TECHNICAL INFORMATION

TI1619

SiGusto / SiVend HG20 Trend

Re-designed "Grounds container holder"

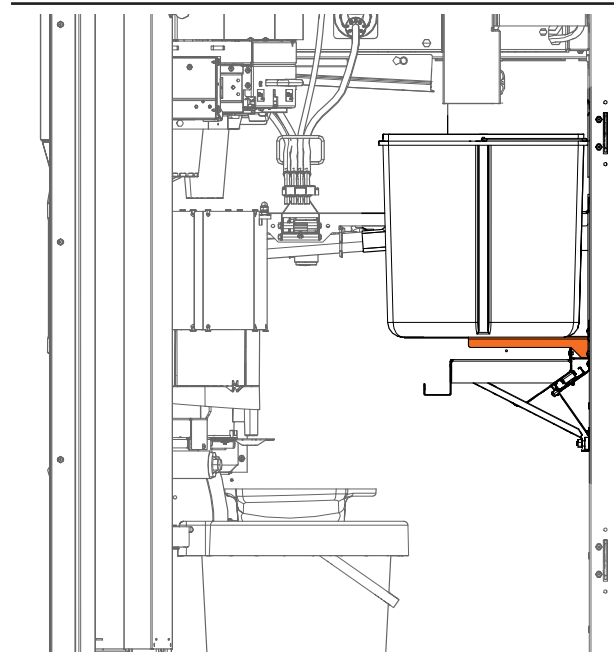
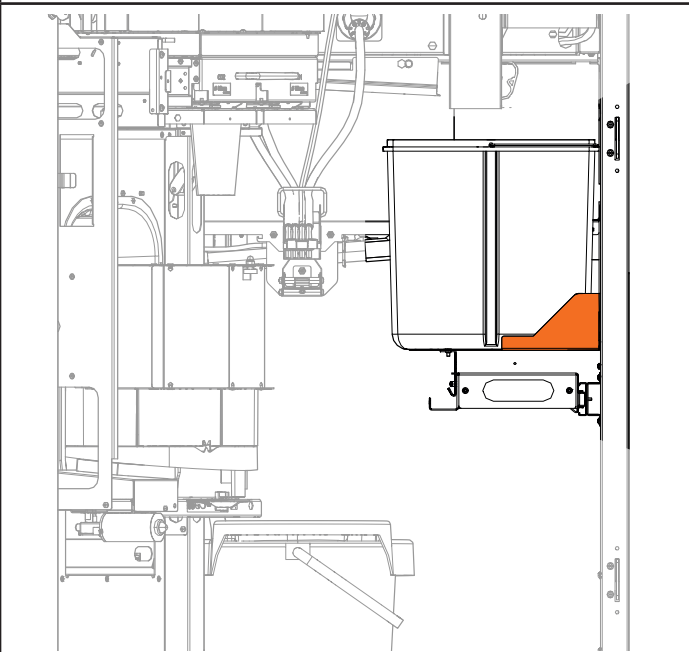
As we continually endeavour to improve our products the holder for the grounds container has been modified.

The shape of the holder, (part no. 412 00 016 00), has been re-designed so that the grounds container can only be positioned correctly.

The new holder has been in serial production since Week 16/2019, machine number 90479445.
